JRPP No: 2010SYE001

D/A No: 200900562

Proposal To erect a residential aged care facility containing 120 beds within a four storey building over basement car park, and a child care centre within a two storey building with off street car parking for 86 vehicles for the entire development.

Manager Development Assessment reports:

Image 12 – Photomontage indicating the relationship between the plantings to be established in the rear courtyard and the quarry face wall

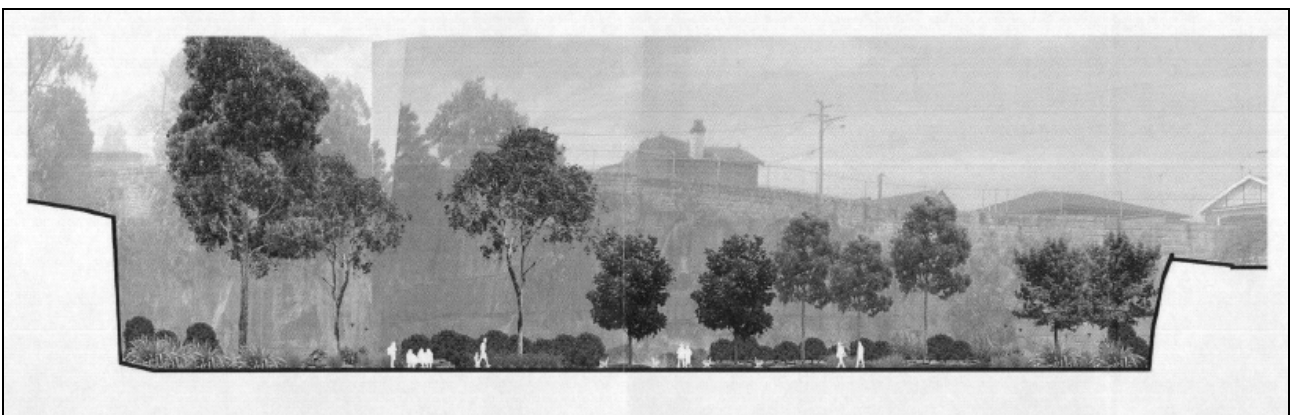
The landscape plan in its current form does not conserve the significance of the quarry face. The placement of screening shrubs and trees against the quarry face obscures its visibility and therefore reduces its significance at the site.

All planting other than low ground cover, should be set back from the quarry face with the aim of maximising its exposure as viewed from on and off the site.

The planting at the north east and south east corners of the site should not obscure views of the quarry wall curving around the site.

The comments provided by Council's Heritage and Urban Design Advisor were forwarded to the applicant for consideration. The applicant subsequently provided an updated landscape plan in which reduced plantings are now proposed directly adjacent to the wall of the quarry. The Landscape Architect made the following submission in describing the landscaping proposed to be established adjacent to the walls of the quarry:

Furthermore, the Landscape Architect provided a photomontage which indicates the relationship between the plantings to be established in the rear courtyard and the quarry face wall (see image 12 below).

The level and type of plants and shrubs to be established adjacent to the quarry face wall are considered to strike an appropriate balance between providing a landscaped setting for the proposed residential care facility and ensuring direct and unrestricted views of the heritage item are maintained.

Image 13 – Front (Illawarra Road) elevation as originally proposed

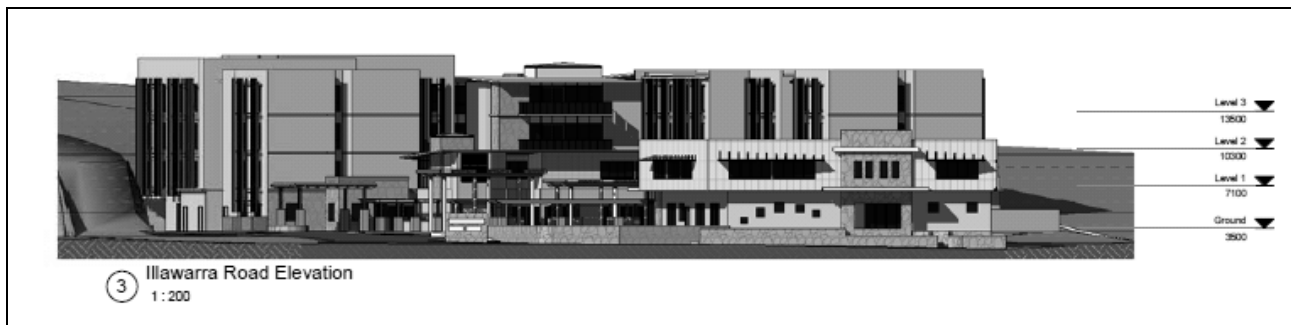
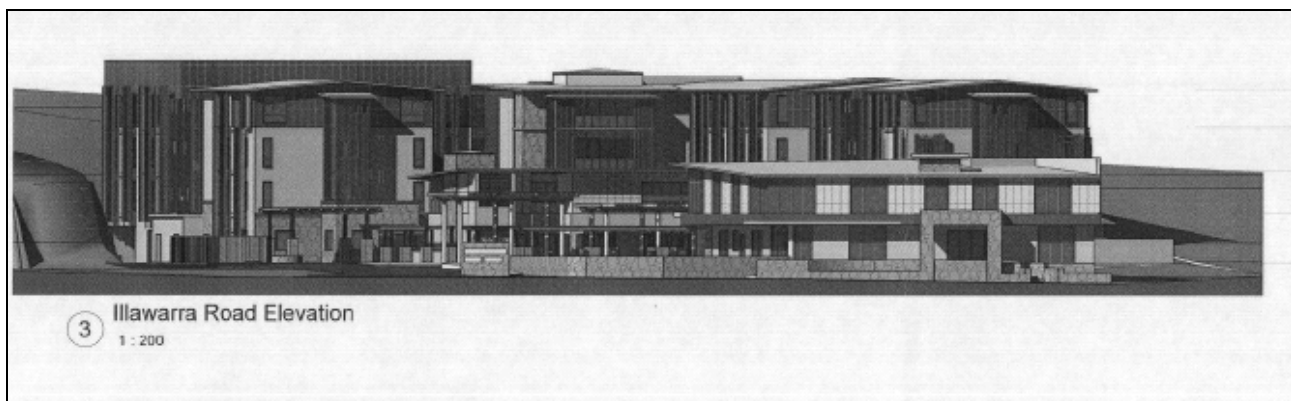
In conducting a peer review of the subject Master Plan Brett Newbold Urban Planning and Urban Design made the following conclusions having regard to the architectural form of the proposed development:

- Within the aged care facility, modular planning of residential units results in cubic building forms with sheer vertical facades and repetition of identical window openings.*

- Perhaps reflecting the architectural desire to emphasise inherently-cubic forms, the majority of roofs in the proposed development are concealed by level parapets, some of which add the appearance of another storey in height.*

- *By contrast to front and rear buildings which display an institutional or commercial design character, the aged care facility's reception and administration building displays much-softer forms that are relatively-compatible with residential character of the site's surroundings."*

The issues raised by Brett Newbold Urban Planning and Urban Design were forwarded to the applicant for consideration. The applicant subsequently submitted amended plans and additional information in line with the comments received during the peer review. Importantly, the applicant made significant amendments to the architectural form to ensure the proposed development responded to the residential character of the surrounding area as opposed to the more institutional/commercial character of the original design. The images below demonstrate the significant amendments that were made to both the architectural form and palette of materials to create a building which better responded to the finer grain detail of the surrounding development.

The following amendments were made to the residential care facility in response to the concerns raised during the peer review process:

- The applicant amended the roof form to include a mix of gables and skillions with low pitches and wide eaves;
- The planar masonry facades were broken up with balcony elements and structures that are designed to appear similar to balconies;

- At the western end of each building wing the corridors were defined by screened balconies which add interest to those facades;
- The planar facades were updated to incorporate elements which provided more effective “animation” thereby adding interest to the overall appearance of the development;

- The top-most storey was amended to consist of panel cladding to add interest to the overall design and to break up the vertical nature of the facades to reduce visual bulk;

- At the western end of each residential wing, the bedroom units were “rotated” ninety degrees to enable windows to be inserted into walls that were previously blank and which provide prominent street backdrop when the development is viewed from Illawarra Road; and
